APPENDIX 4:
TECHNICAL EVIDENCE FROM COUNCIL SPECIALISTS

SUBJECT: **LUC-2021-619**
317 CHAIN HILLS ROAD, TAIERI

SUBJECT: LUC-2021-619
317 CHAIN HILLS RD
DUNEDIN – LA Comments

SUBJECT: LUC-2021-619 – 317 CHAIN HILLS ROAD – PROPOSED NON-COMPLYING RESIDENTIAL ACTIVITY ON UNDERSIZED RURAL LOT

Figure 3: Existing dwellings on the hillslopes above Wingatui

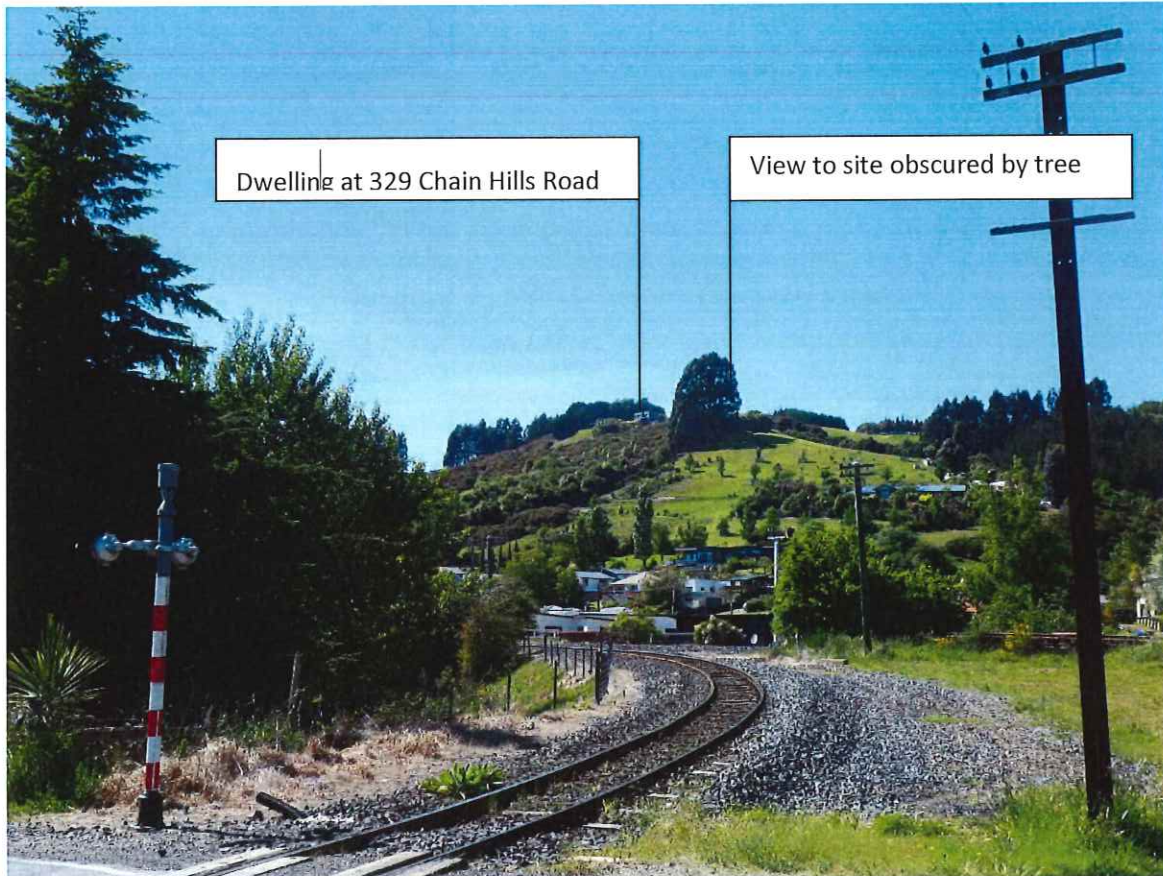
- Whilst built development on the nearby hillslopes is largely concentrated on the upper slopes/ridge and the proposed building site is somewhat lower on the upper-mid slopes, it will be seen in the context of these other nearby dwellings as shown in Mr Moore's figure 3 and site photos attached in Appendix 1 of this memorandum. As such, this development will not be introducing a wholly new type of development into this environment, rather, it will increase the ratio of built form to natural landcover somewhat.

Figure 1: Restoration and covenant zones at 317 Chain Hills Road (figure taken from restoration plan provided by applicant).

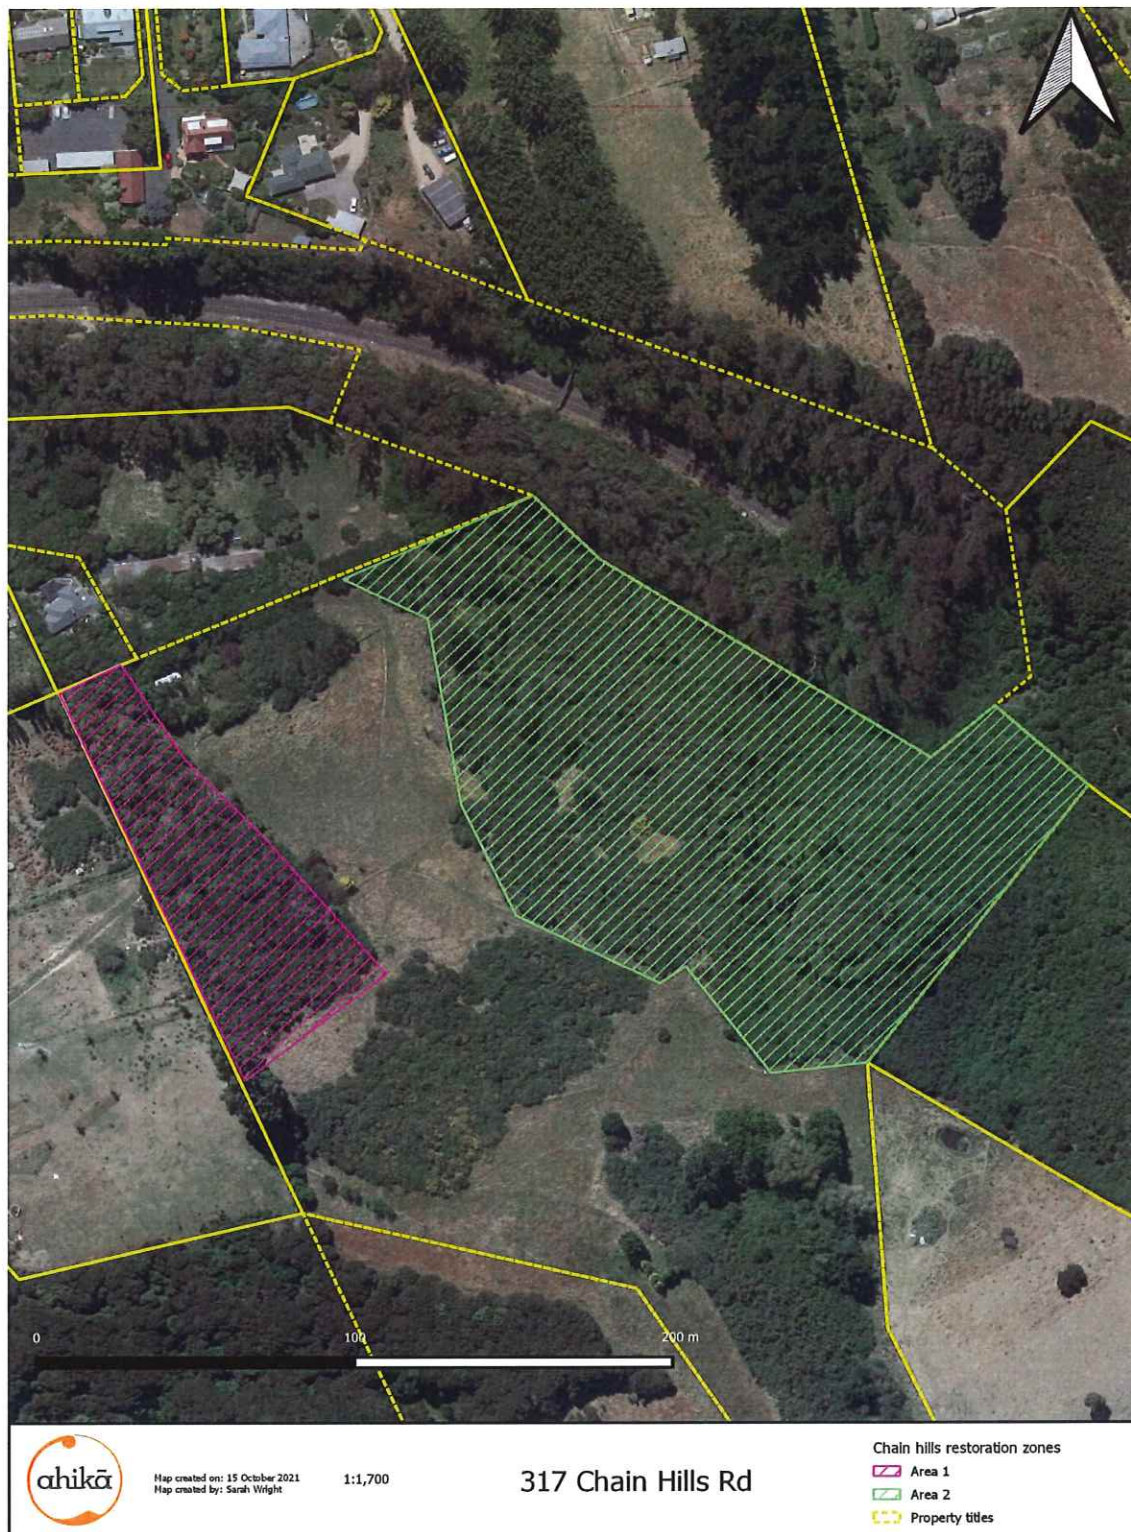
8. Two sites were selected for restoration (based off guidance from Richard Ewans), Area 1 (0.5 ha) and 2 (2.2 ha) (Figure 1). Both areas are dominated by gorse with some emergent natives. No indigenous fauna was observed at the site however several native birds and skink species are common in the wider Chain Hills area.
